Brunel Retail Park – Response to Highways Comments dated 20th April 2021 in relation to the proposed redevelopment of the Park

From: (e)Transport Development Control Floor 1 North Rear Civic Offices Bridge Street Reading RG1 2LU
To: Alison Amoah 0118 9372286 alison.amoah@reading.gov.uk
Date: 20 April 2021
Re: Consultation on Planning Application

Application Number: 201853

Address: Brunel Retail Park Rose Kiln Lane Reading

Drawing Title
2.4m x 43m Visibility Splays

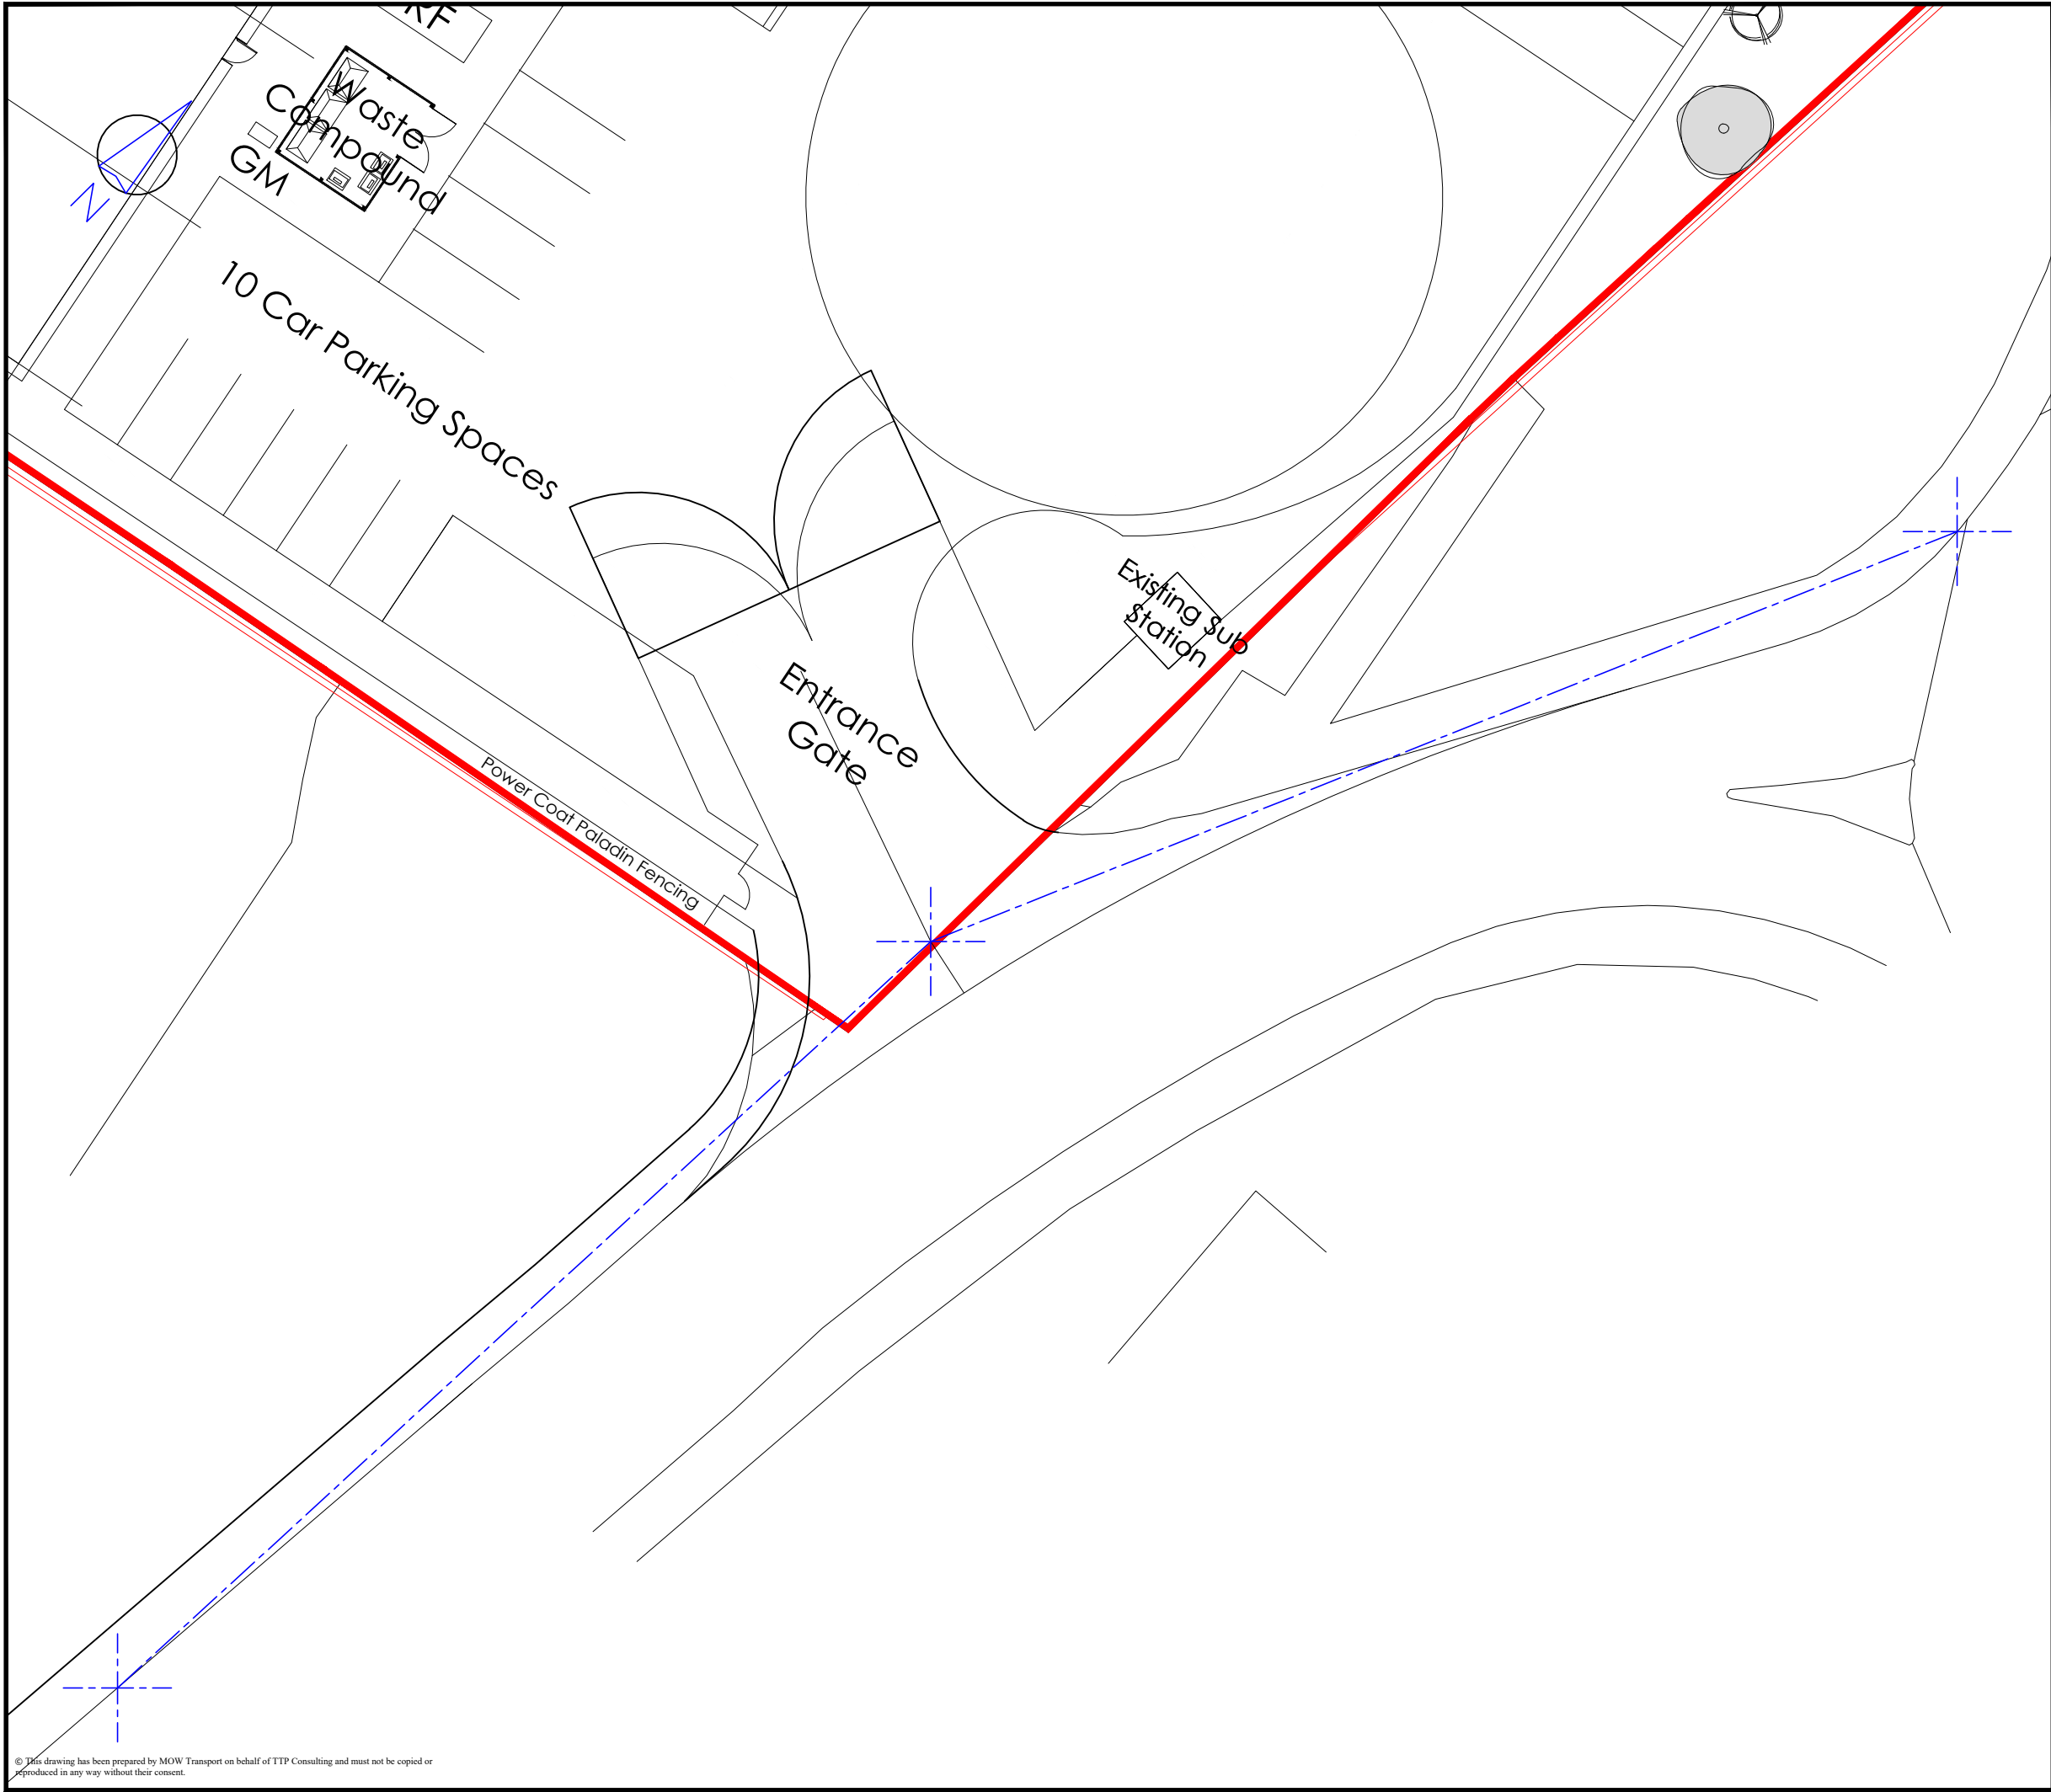
Revised drawings would therefore be required illustrating visibility splays for any access to a car parking area which should be 2.4m x 43m.

The proposal does however include a dedicated access to the parking for Phase 2 and therefore visibility splays would be required at this junction/access of 2.4m x 43m.

Rev	Details	Drawn	Checked	Date
A	Scheme and visibility splays updated.	MW	AM	12.05.21

Drawing Title
Swept Path Analysis Using a 16.5m Articulated Vehicle

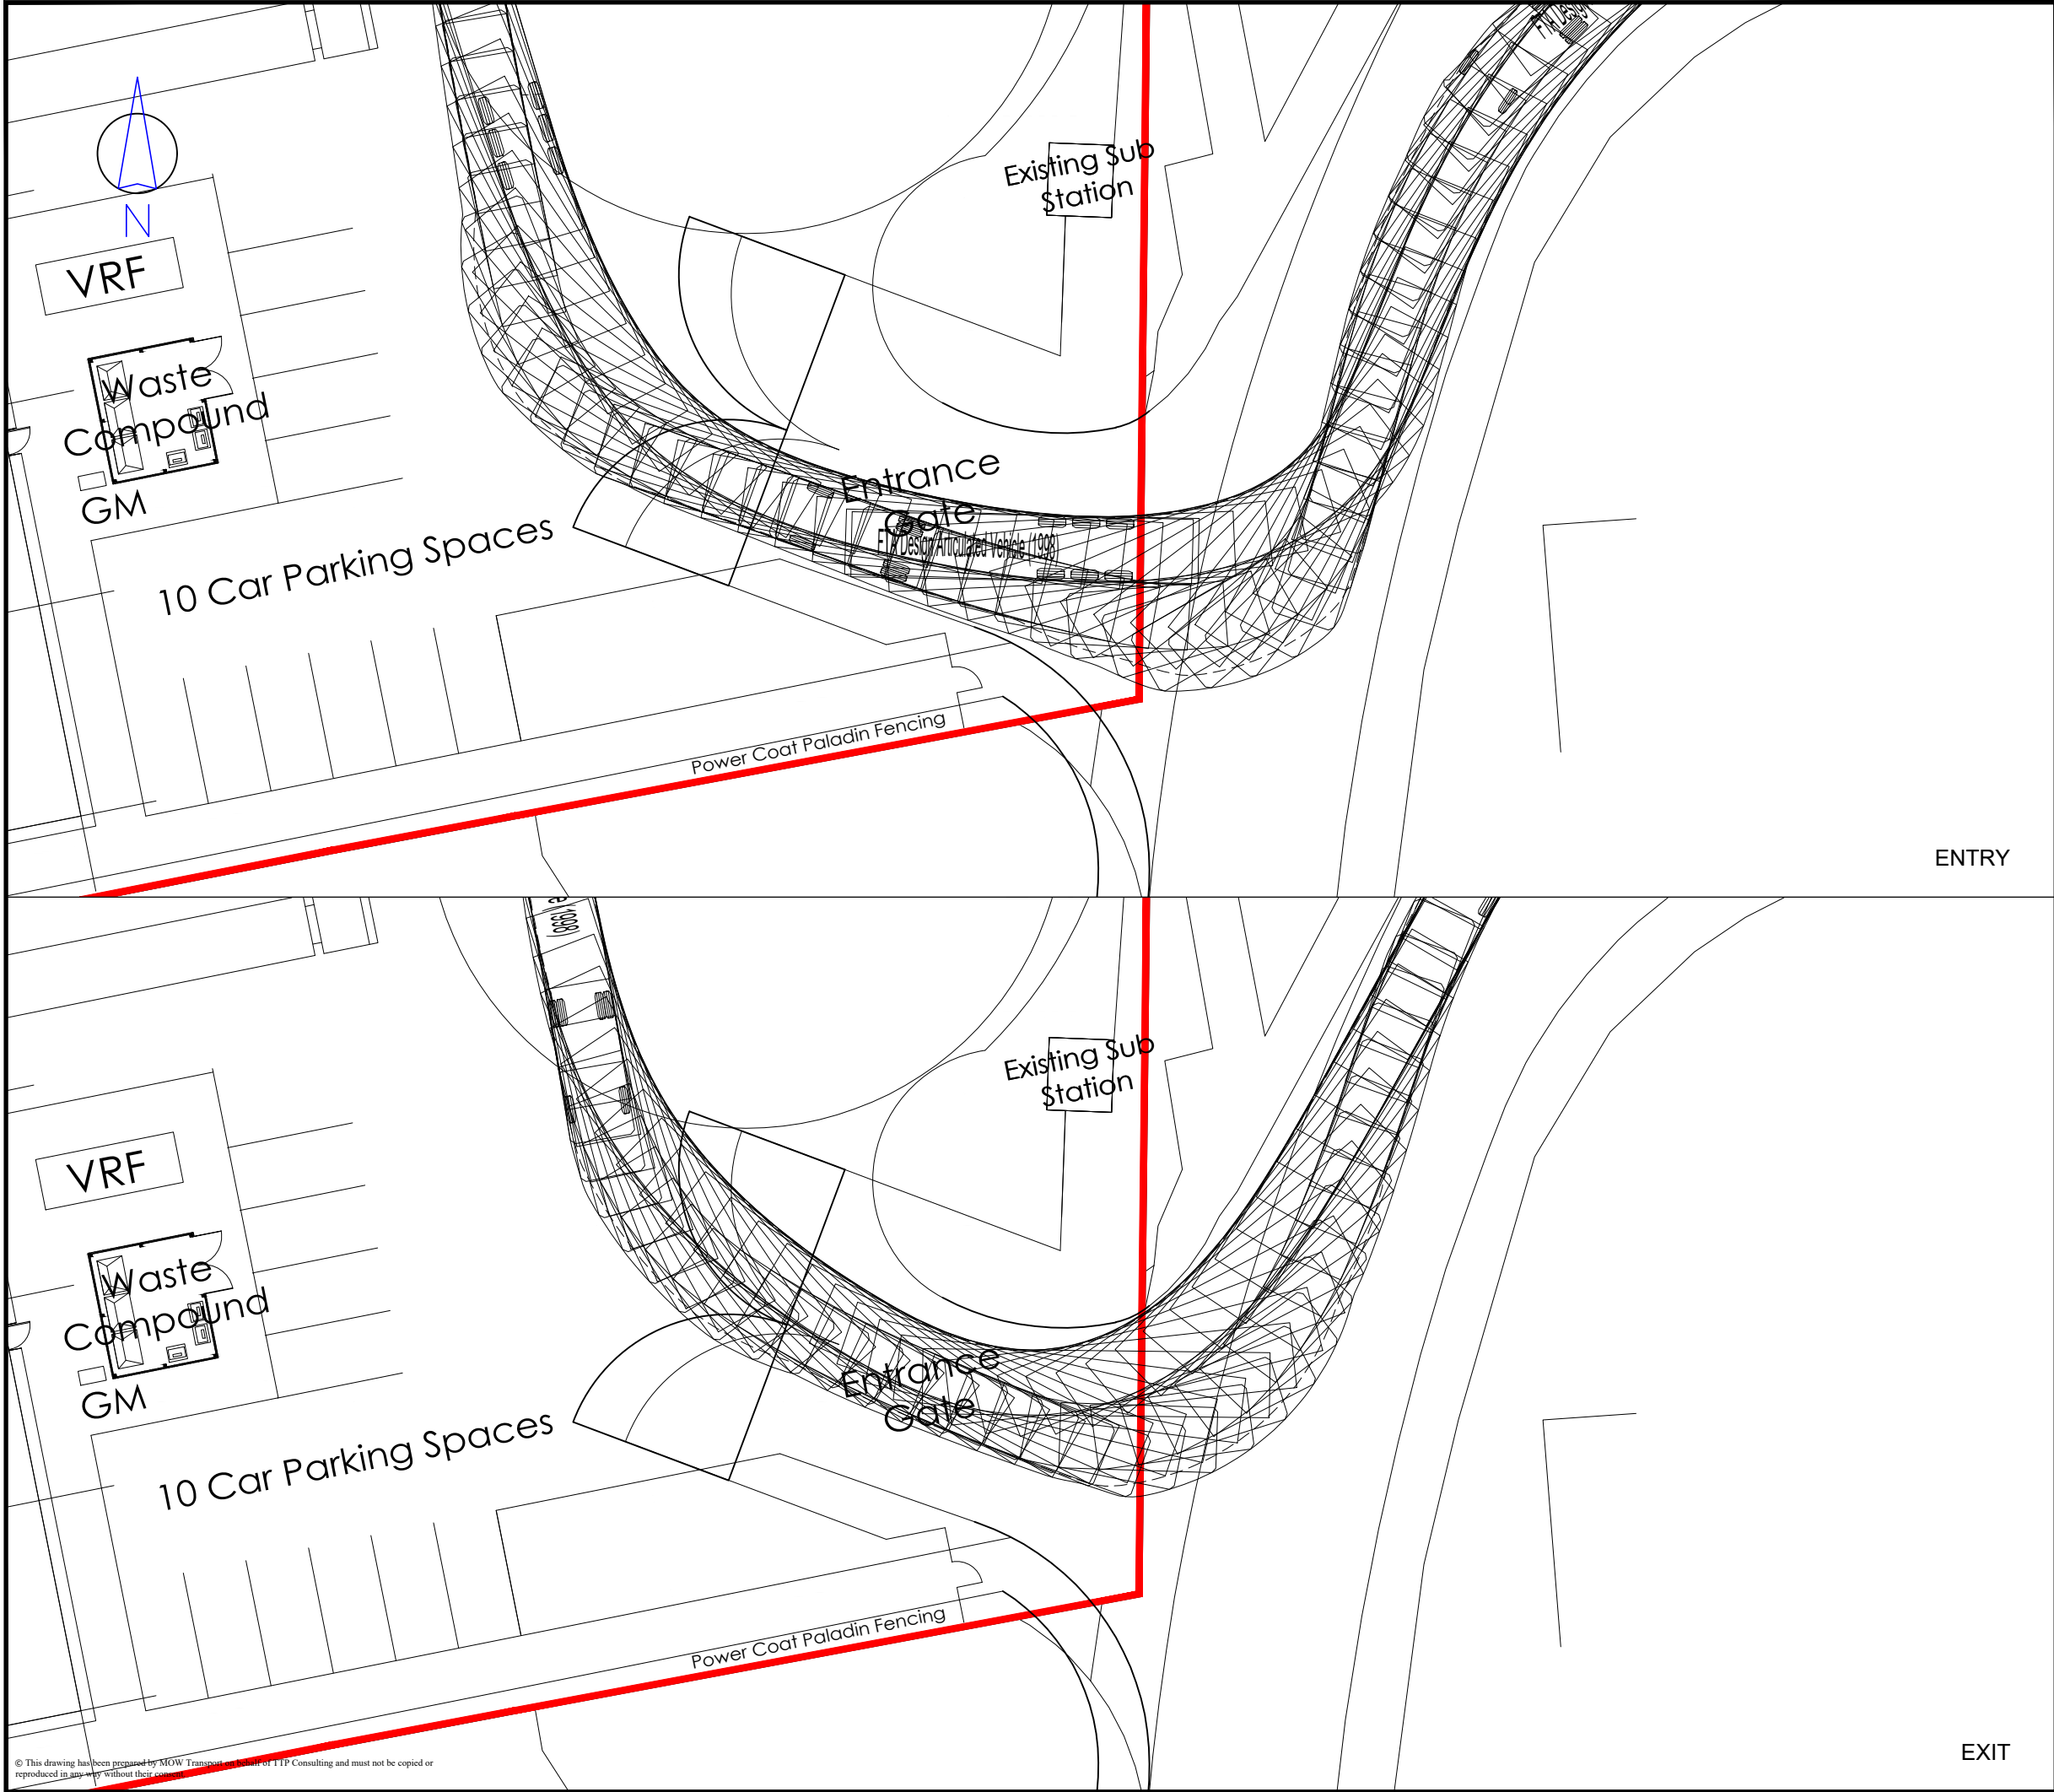
The proposed altered access onto Gillette Way illustrates the provision of gates within 6m of the Public Highway which is a significant reduction from the set back distance of 20m as is provided currently. The proposal will therefore result in articulated vehicles obstructing the flow of traffic along Gillette Way whilst they await entry into the site and as such this cannot be supported by the Highway Authority. Any access design and gate location should ensure that no vehicle is obstructing the carriageway.

The Transport Assessment states that drawings indicating the vehicle tracking is shown in Appendix C, however on review of the TA it is noted that Appendix C is not provided. As such the Highway Authority are unable to ascertain whether the internal road network is sufficient.

The proposed altered access onto Gillette Way illustrates the provision of gates within 6m of the Public Highway which is a significant reduction from the set-back distance of 20m as is provided currently. The proposal will therefore result in articulated vehicles obstructing the flow of traffic along Gillette Way whilst they await entry into the site and as such this cannot be supported by the Highway Authority. Any access design and gate location should ensure that no vehicle is obstructing the carriageway.	Strictly speaking the existing gate is on the line of the adopted highway which extends into the service road as illustrated on the highway boundary plan in Annex C. However, it is acknowledged that the proposed gate is closer to Gillette Way. Although there is precedent with the Tesco service yard being closer, the location of the gate has been moved further within the Site to accommodate an articulated HGV clear of the running carriageway.
